Lee Nuclear Station Units 1 and 2

Evaluation of 2012 Field Investigation Results for Plant Relocation

FIGURE 2.5.1-220

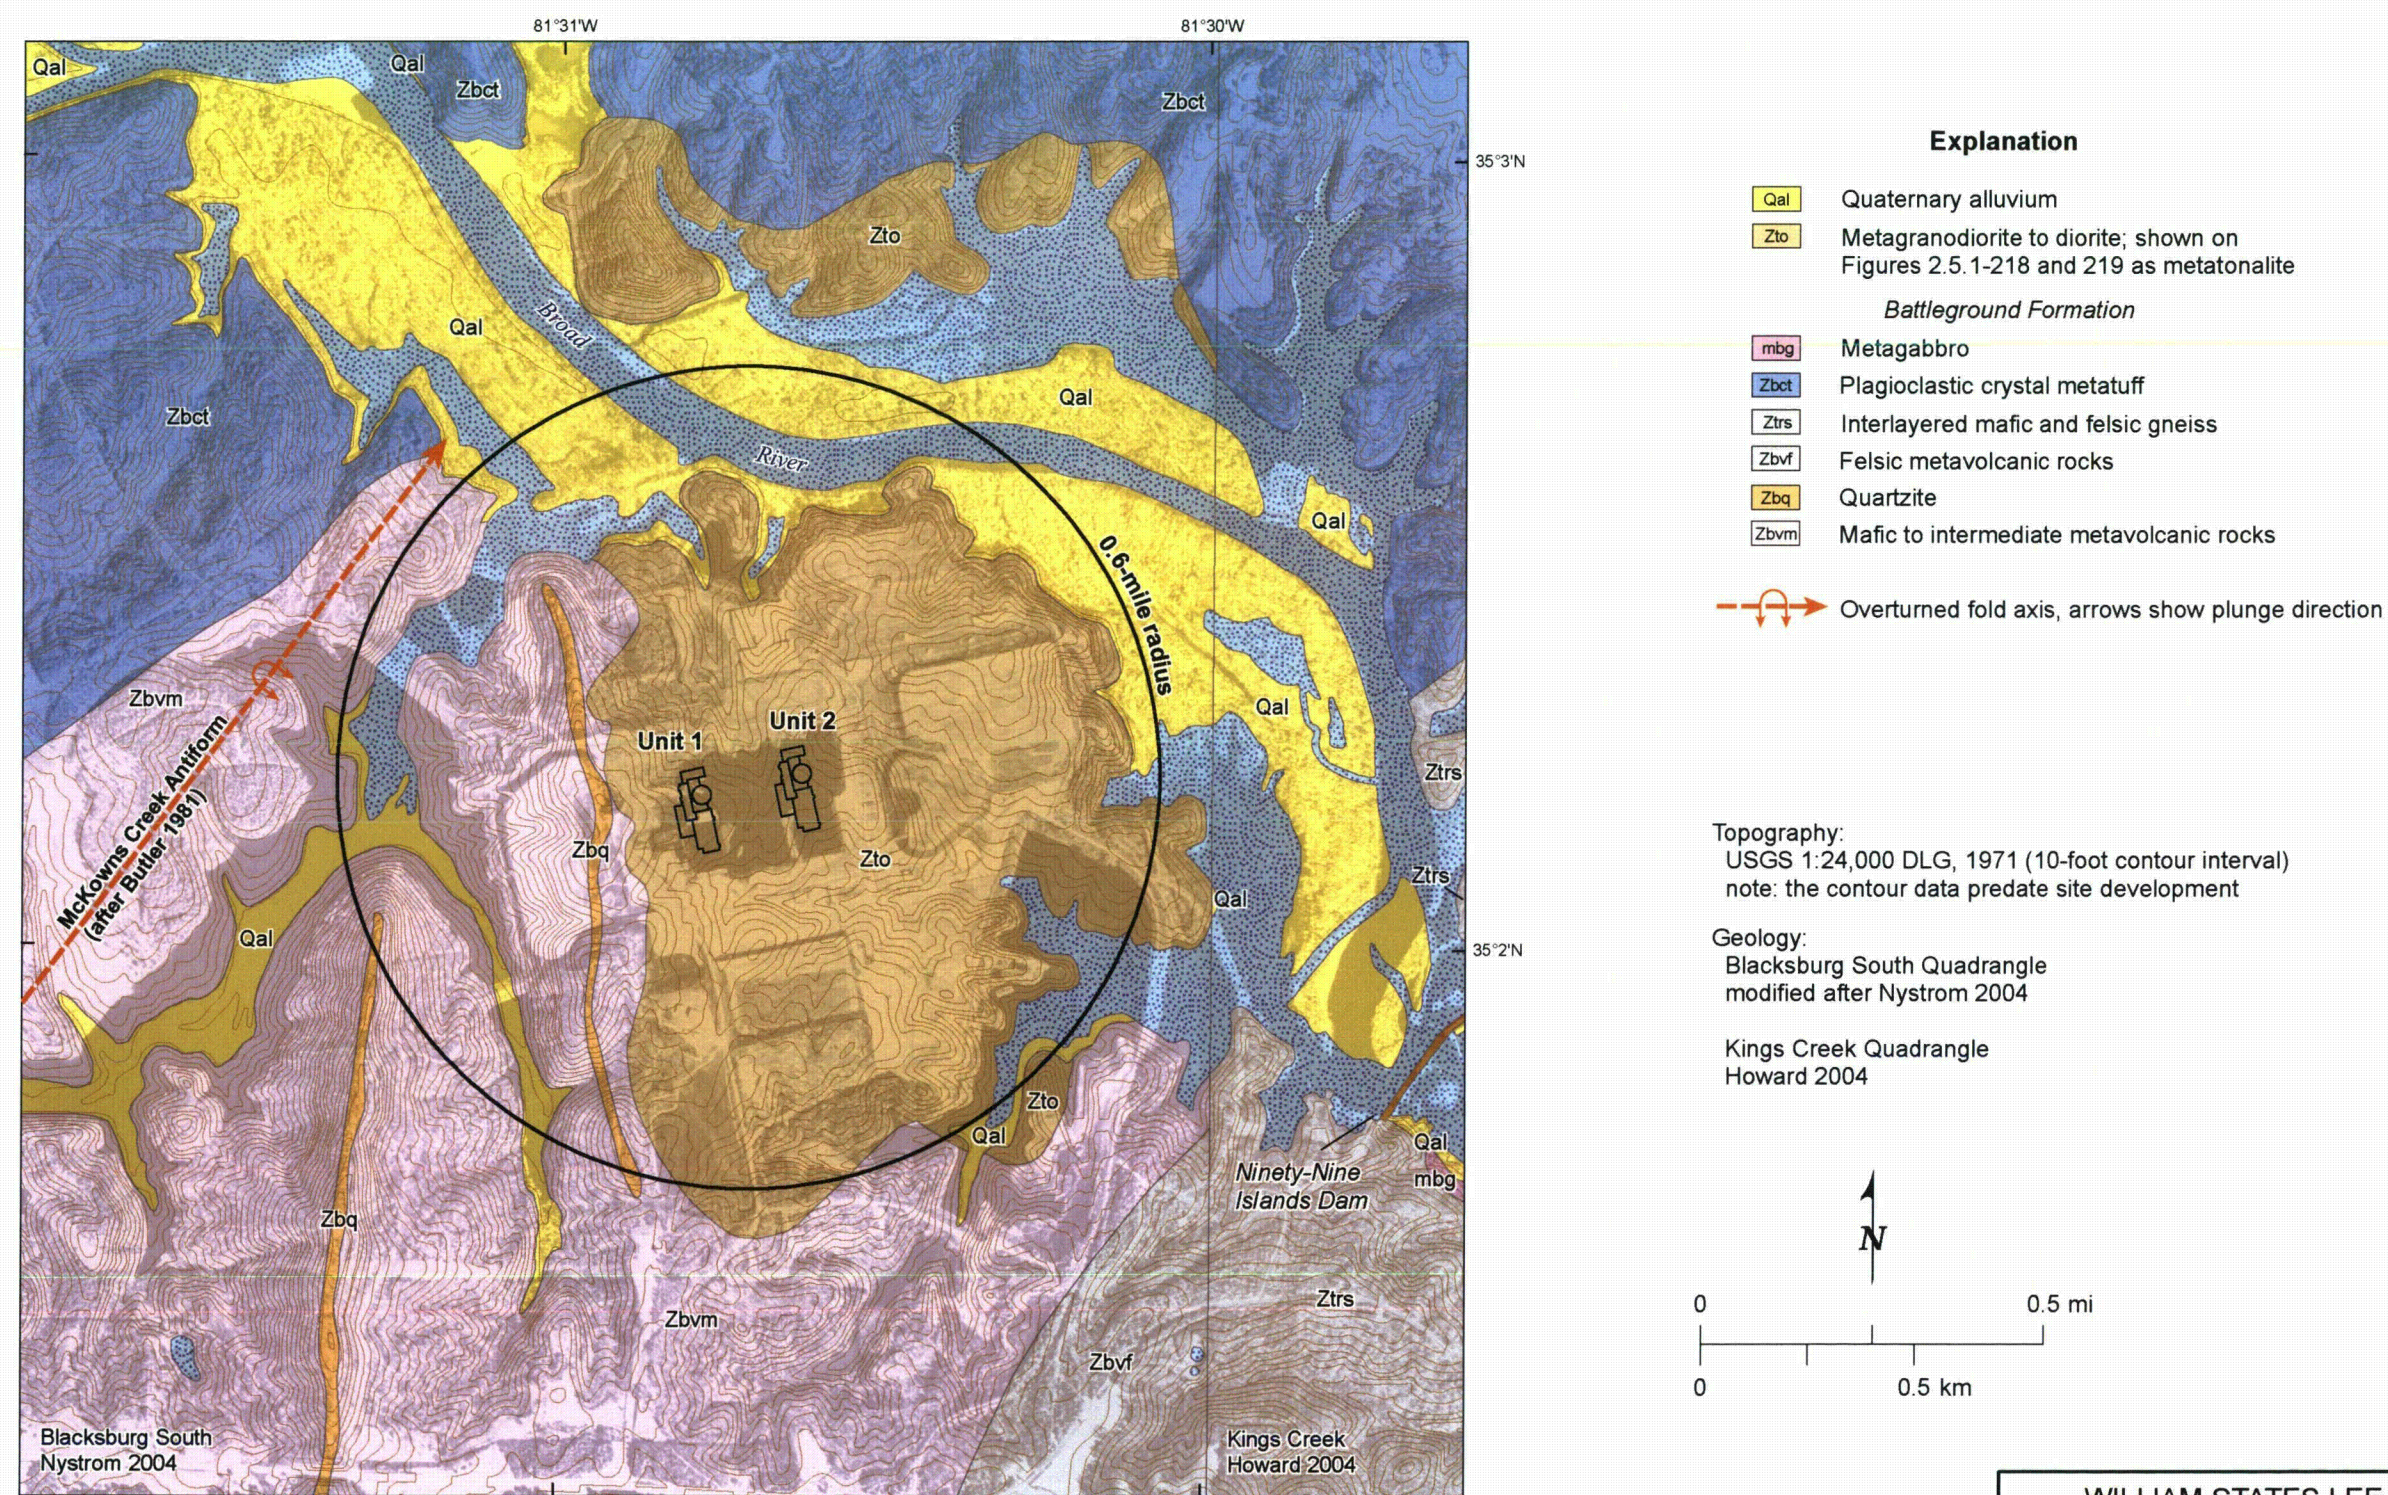
- FSAR Figures 2.5.1-220, Site Geologic Map, and 2.5.1-229, Surficial Geologic Map of Existing Excavation will be revised to illustrate the relocated Lee Nuclear Station.

1. COLA Part 2, FSAR Chapter 2, Figure 2.5.2-220 is revised as follows:

FIGURE 2.5.1-229

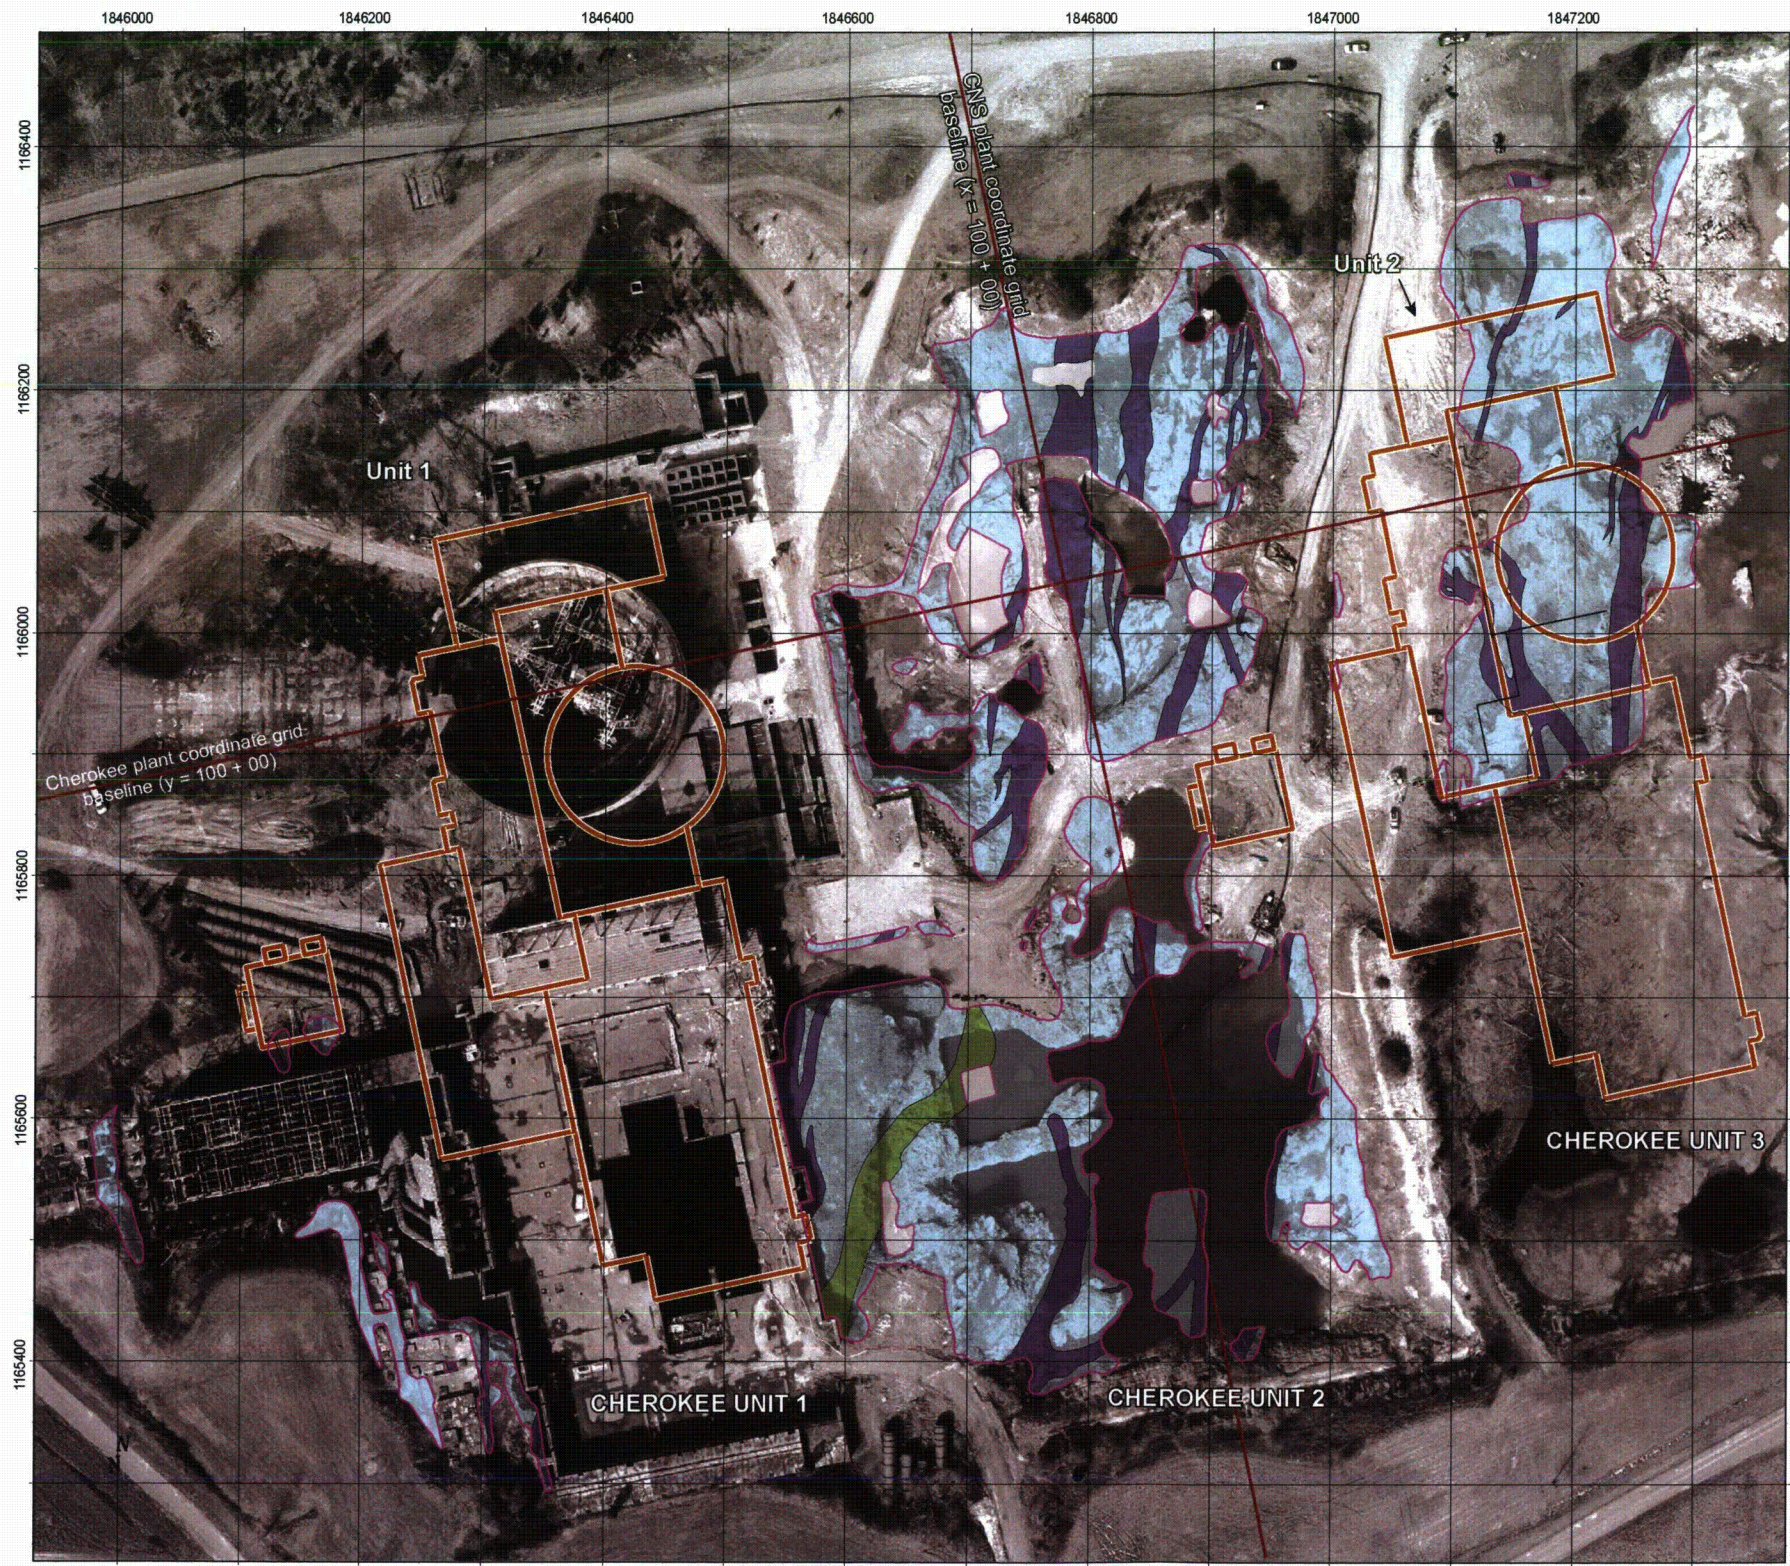
2. COLA Part 2, FSAR Chapter 2, Figure 2.5.1-229 is revised as follows:

FIGURE 2.5.2-240a

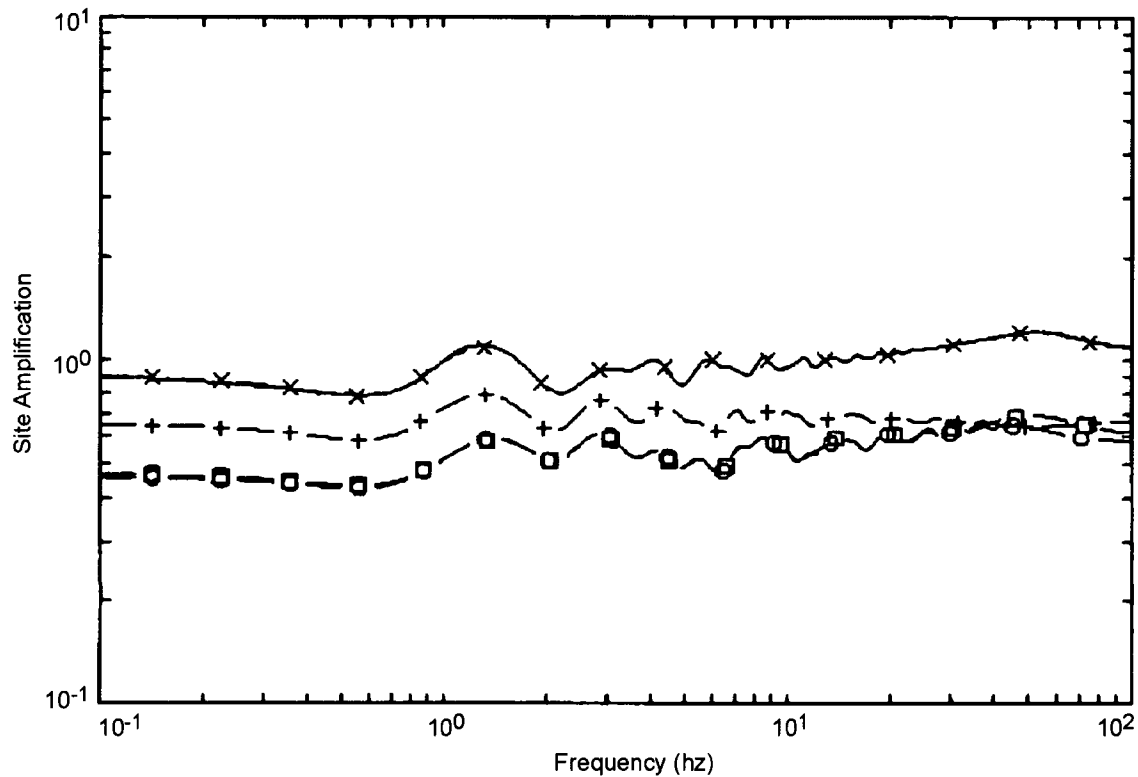
19. COLA Part 2, FSAR Chapter 2, Figure 2.5.2-240 is deleted and presented as Figure 2.5.2-240a, Figure 2.5.2-240b, and Figure 2.5.2-240c as follows:

20. COLA Part 2, FSAR Chapter 2, Figure 2.5.2-240a is added as follows:

FIGURE 2.5.2-240b

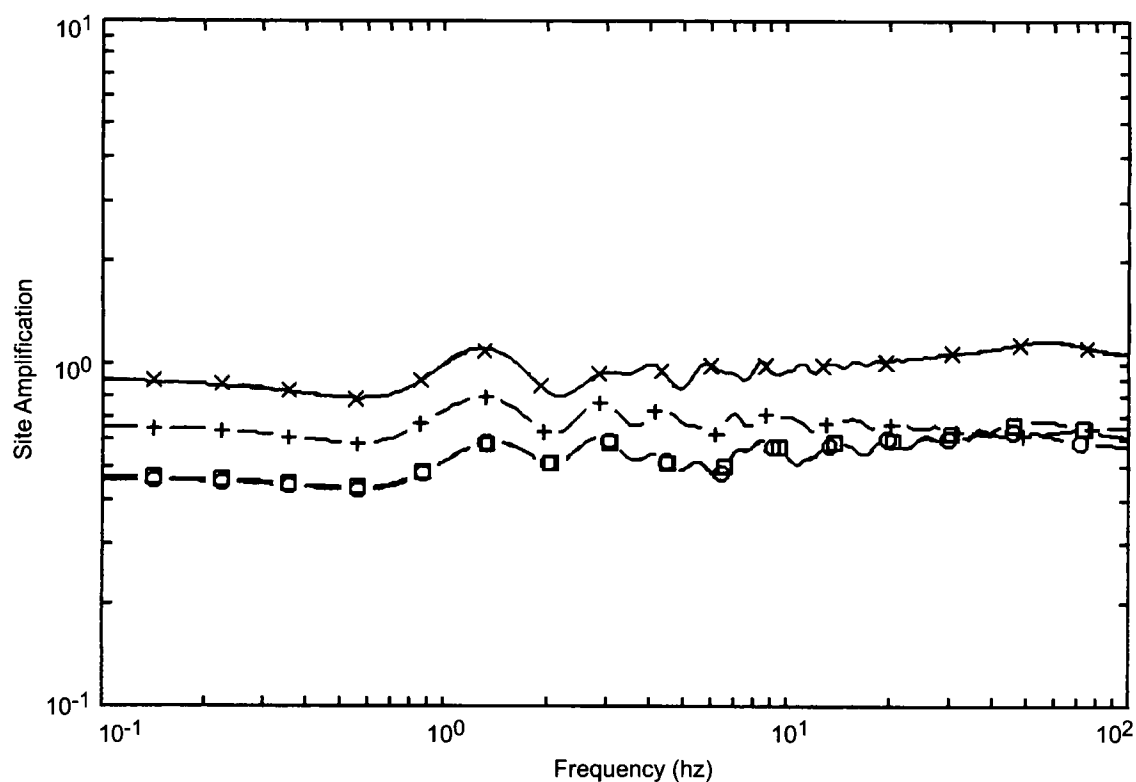
21. COLA Part 2, FSAR Chapter 2, Figure 2.5.2-240b is added as follows:

FIGURE 2.5.2-241a

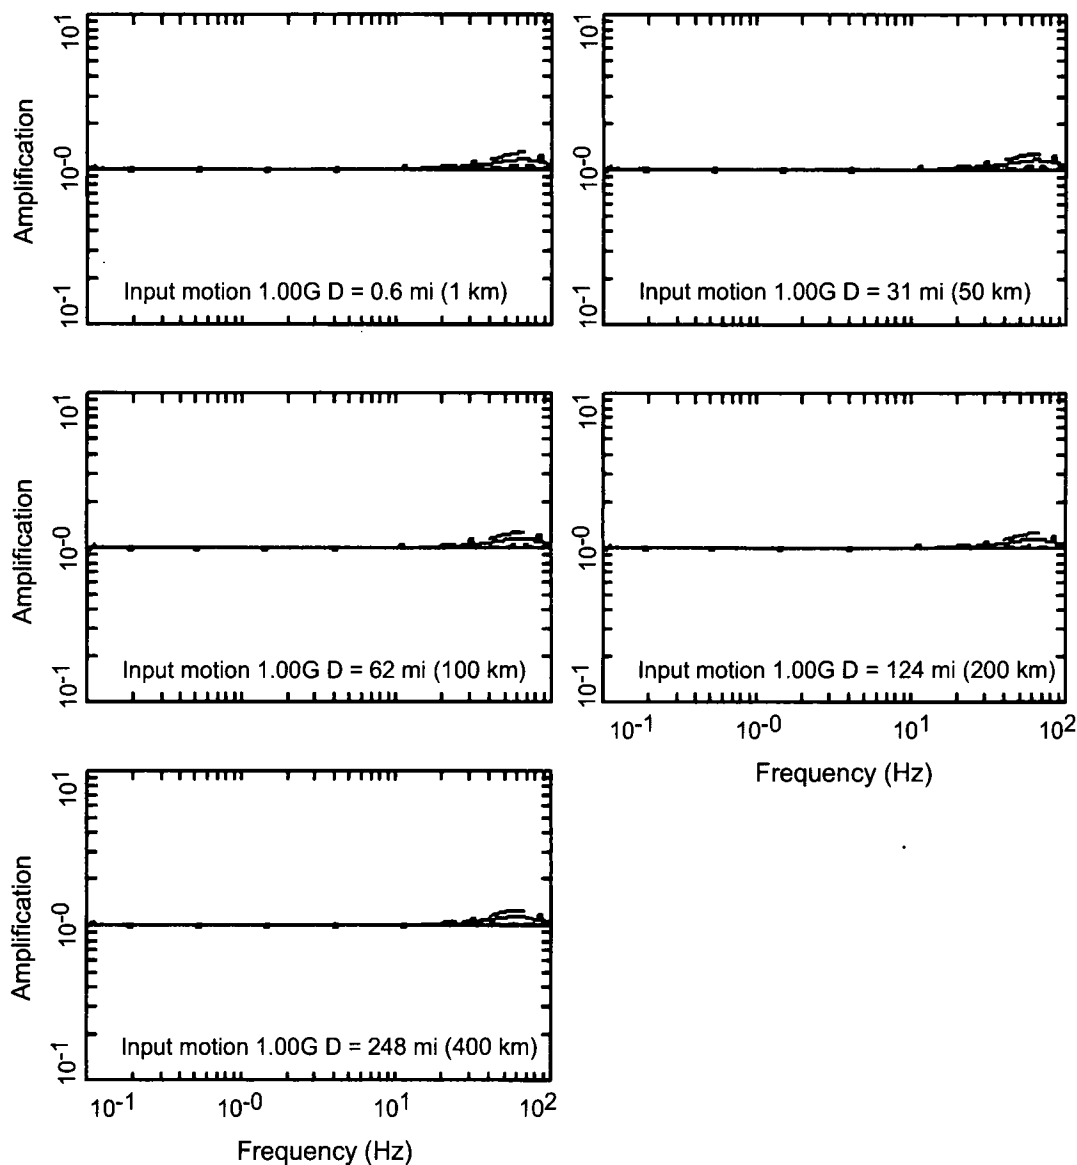
23. COLA Part 2, FSAR Chapter 2, Figure 2.5.2-241 is deleted and presented as Figure 2.5.2-241a, Figure 2.5.2-241b, and Figure 2.5.2-241c as follows:

24. COLA Part 2, FSAR Chapter 2, Figure 2.5.2-241a is added as follows:

FIGURE 2.5.2-241b

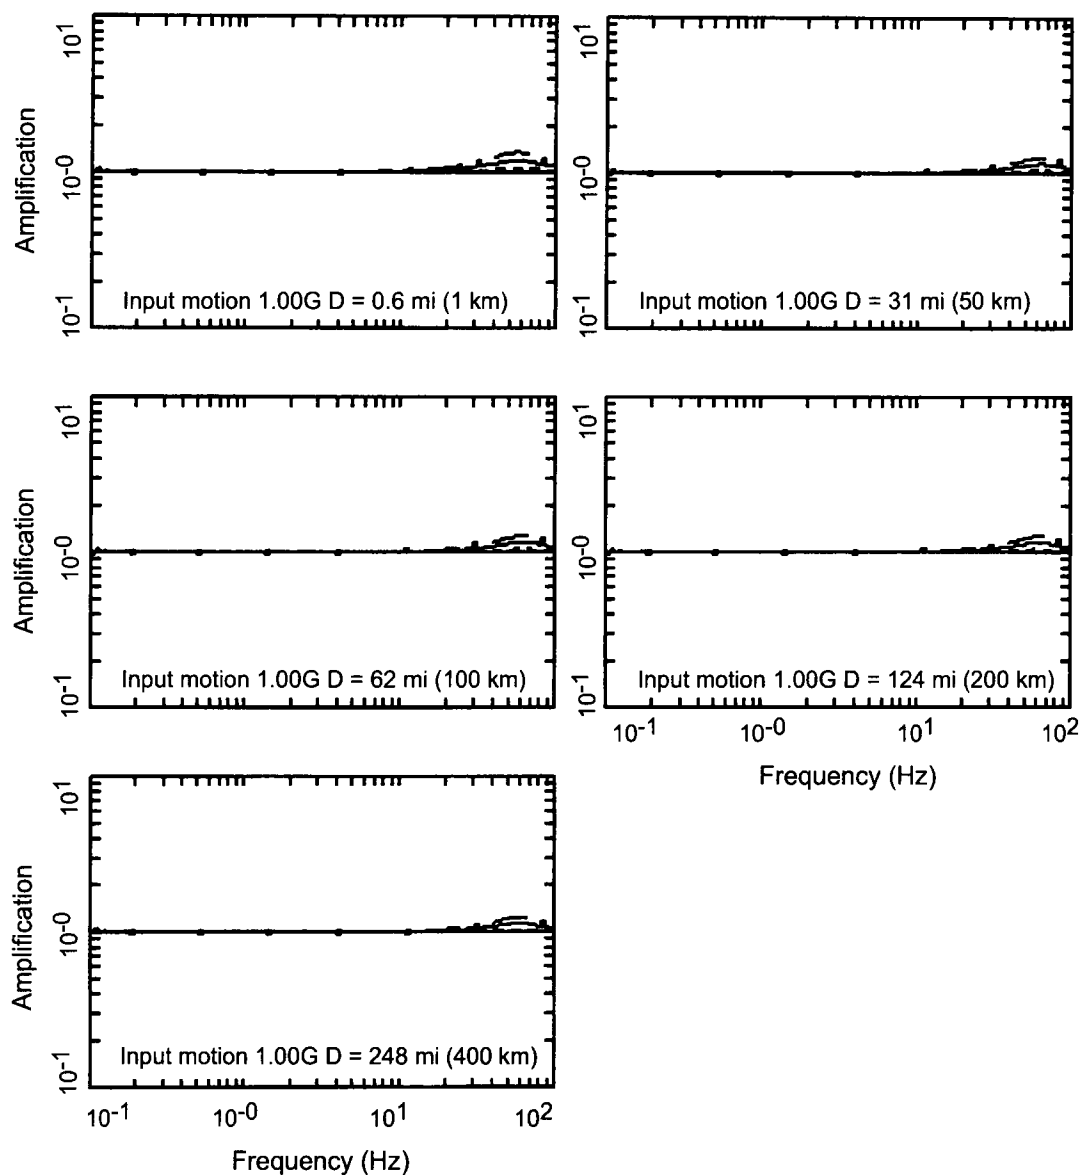
25. COLA Part 2, FSAR Chapter 2, Figure 2.5.2-241b is added as follows:
